STRUTHERS RANCH SUBDIVISION, FILING NO. 5

DRAINAGE LETTER REPORT

October 26, 2020
Revised May 10, 2021
Project No. 20-288
PCD File No. VR211

Inlet DP 2

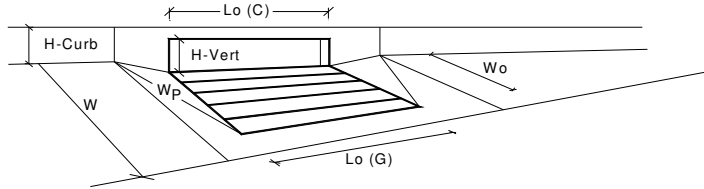
Per developed conditions drainage map, design point 2 flows do not match. Please update to remove inconsistencies.

Unresolved. Revise Qpeak required to 4.4 & 9.4. Update the design accordingly to provide sufficient capacity.
